FINAL RECORD DRAWINGS
 11-04-14

RALSTON CREEK

ERODED BANK REPAIR DETAILS 1

ERODED BANK REPAIR DETAILS 2

ERODED BANK (SOUTH) REPAIR: PLANVIEW (NTS)

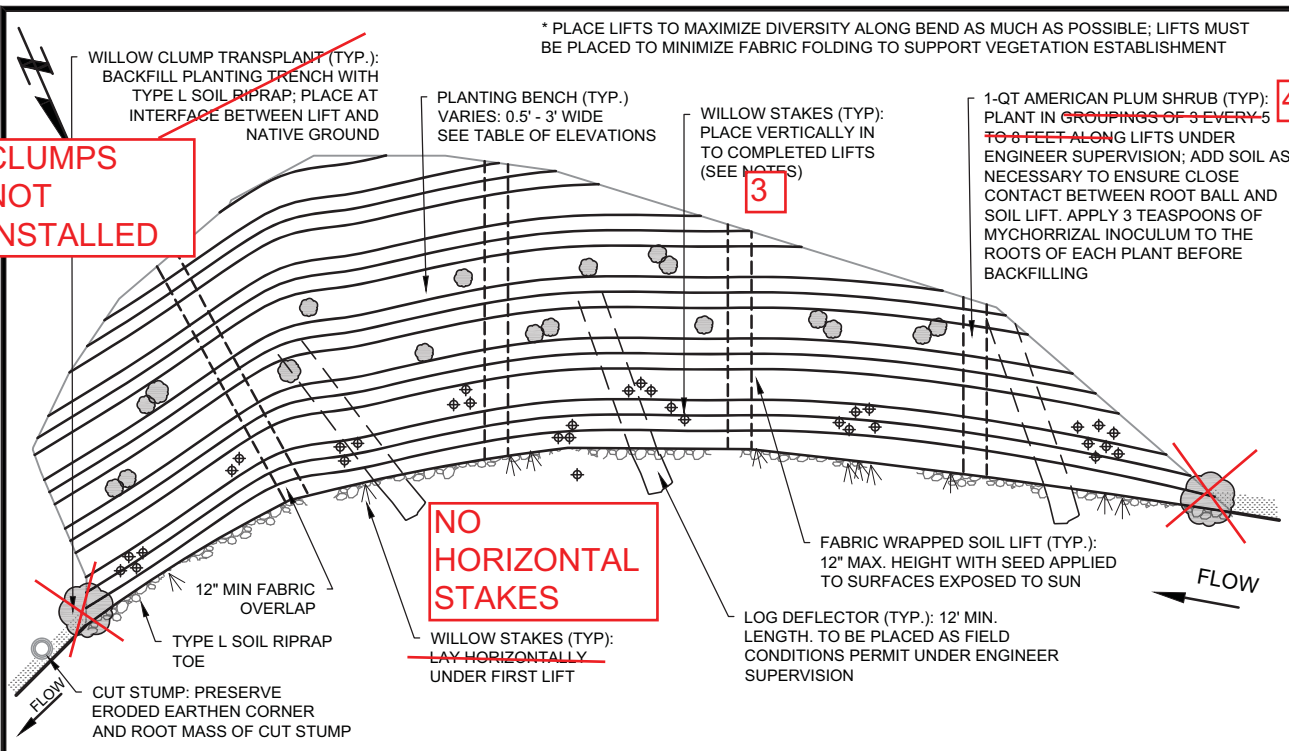
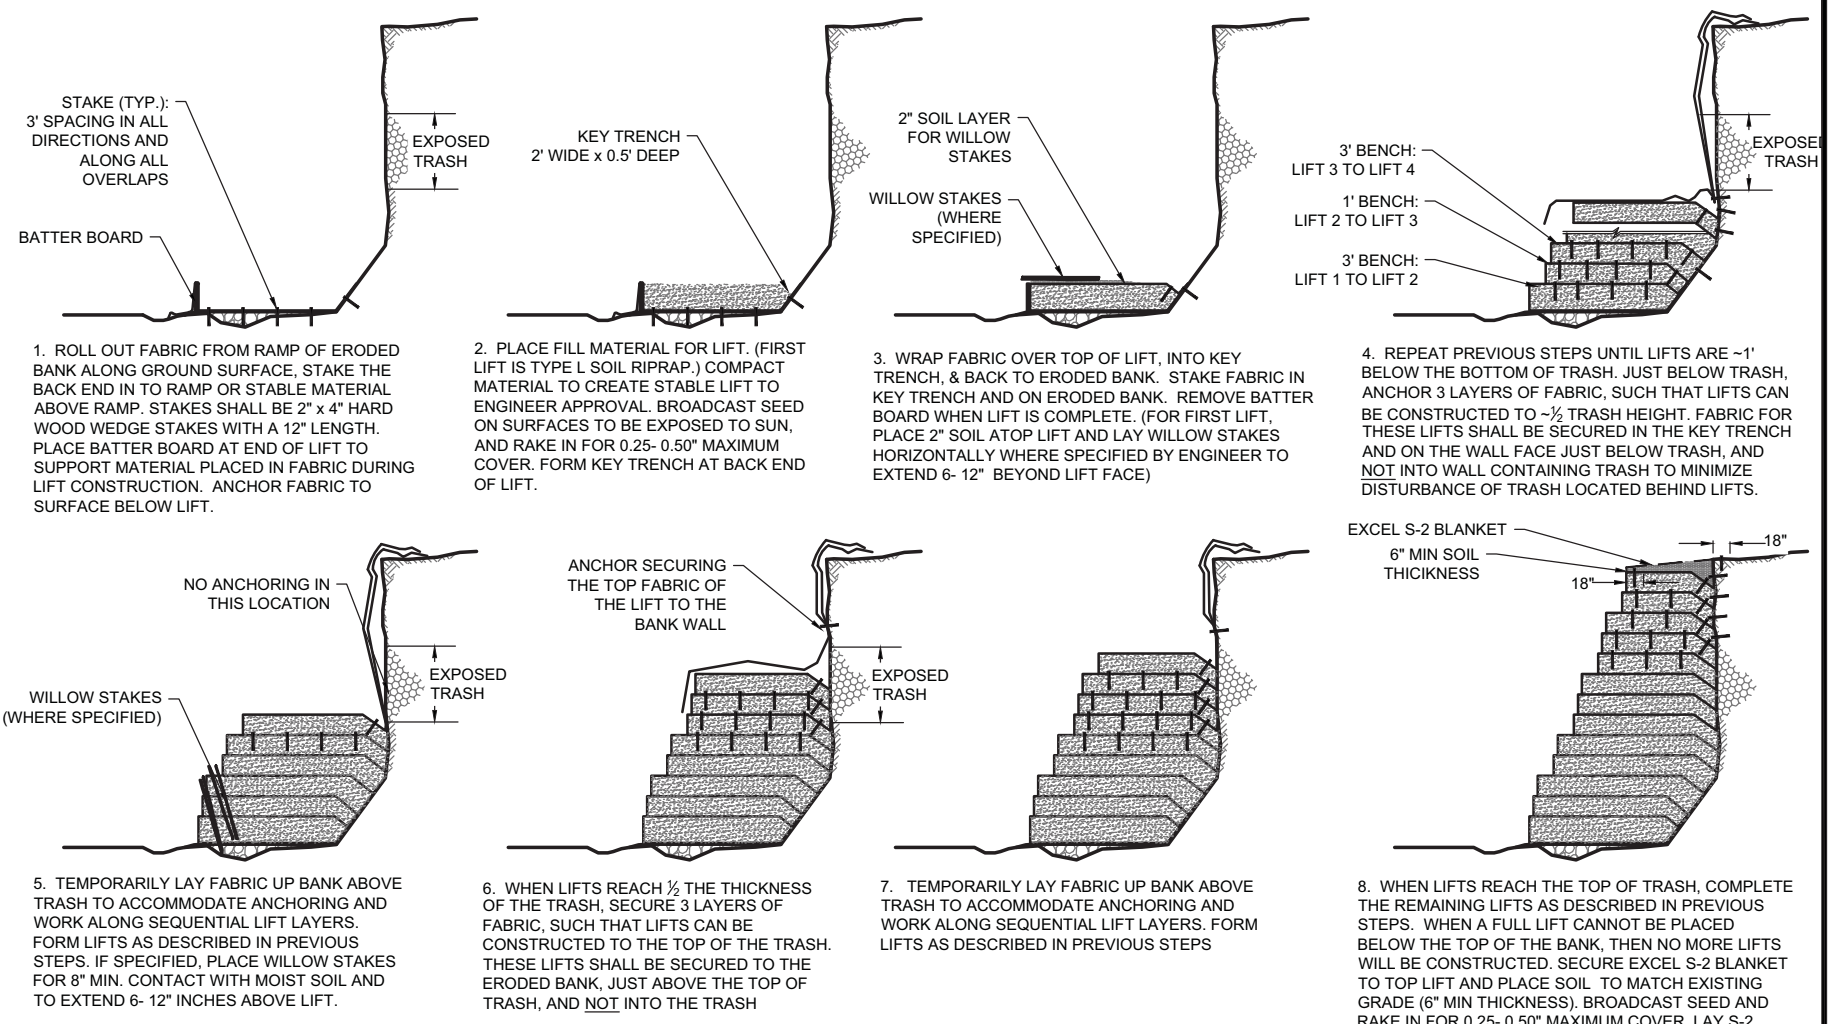
CLUMPS NOT INSTALLED

NO HORIZONTAL STAKES

HYDROMULCH APPLIED IN LIEU OF S-2 BLANKET

3. WILLOW STAKES PLACED ONLY IN LIFTS 1 AND 2
4. 13 AMERICAN PLUMS PLACED VERTICALLY ON LIFTS 8 AND 10; 3 PLUMS PLACED HORIZONTALLY BETWEEN LIFTS 4 AND 6; 4 PLUMS PLACED ON NORTH BANK
5. ADDITIONAL SOIL NOT REQUIRED TO MEET TOP OF SLOPE ELEV

1 DUCKBILL INSTALLED PER DEFLECTOR ON U/S SIDE

DUCKBILLS NOT INSTALLED

ERODED BANK (NORTH) REPAIR: PLANVIEW

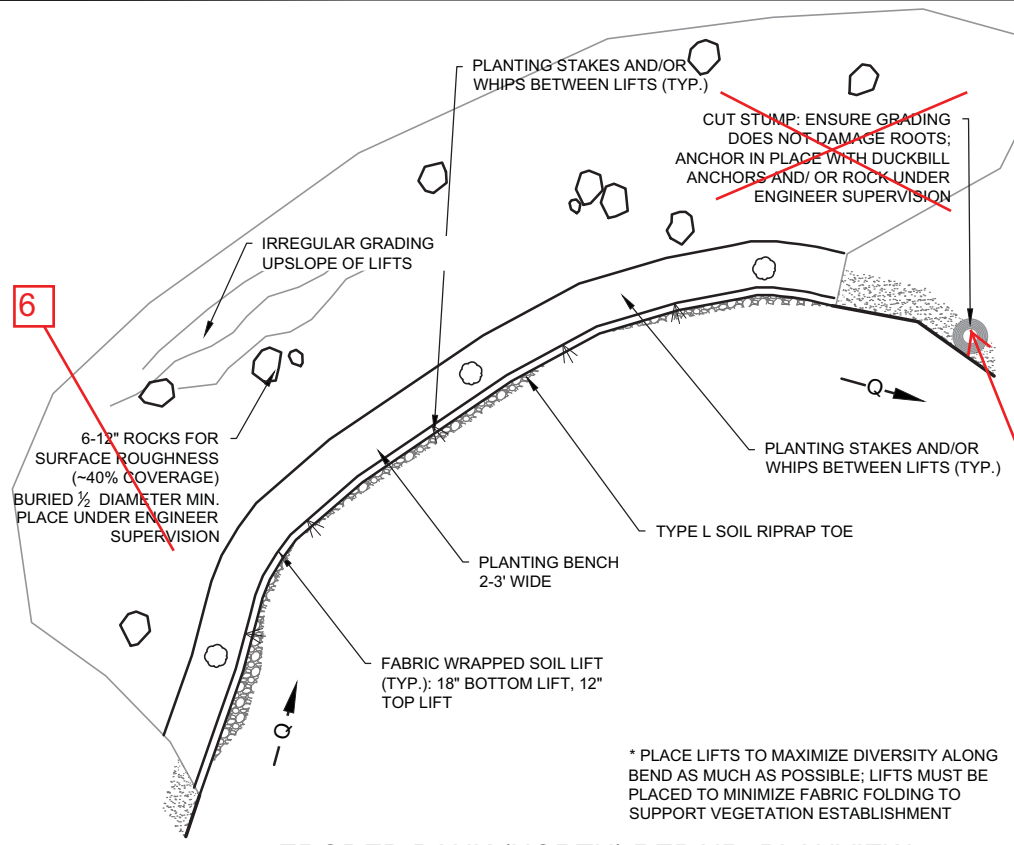
STUMP REMOVED. SEE NOTE 2

ERODED BANK (NORTH) CROSS SECTION AND LIFT CONSTRUCTION

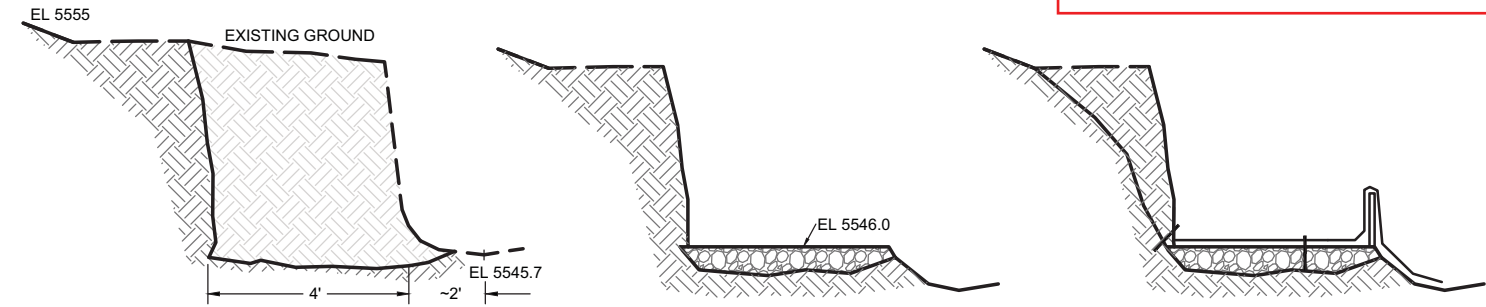
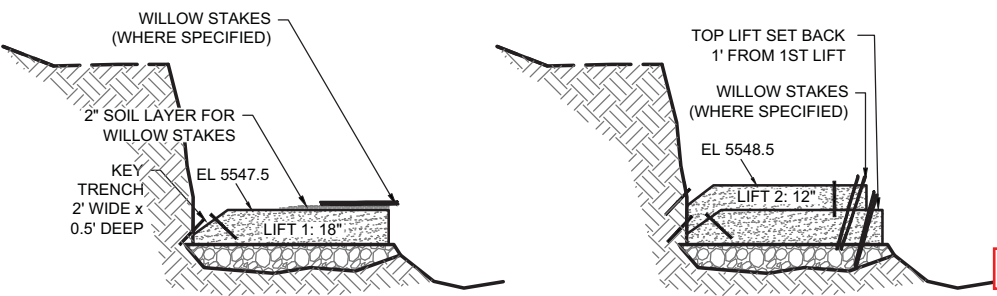
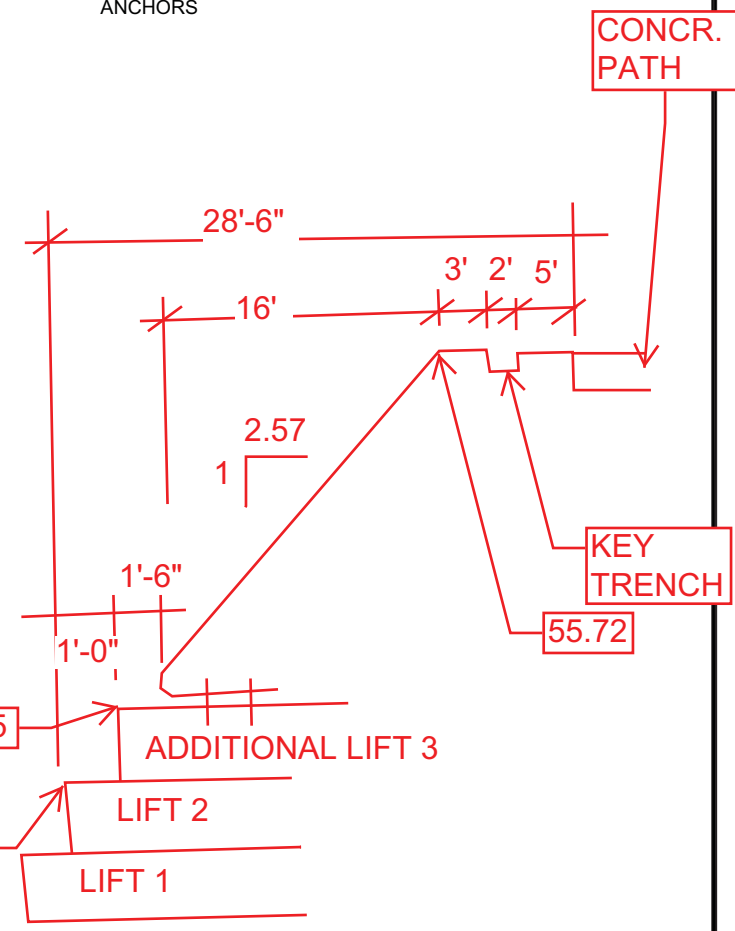
3 LIFTS PLACED. SEE SKETCH

EFFECTIVE SLOPE UPDATED TO ~2.6:1 DUE TO THIRD LIFT.

6. ROCKS NOT PLACED TO IMPROVE BLANKET CONTACT WITH SOIL
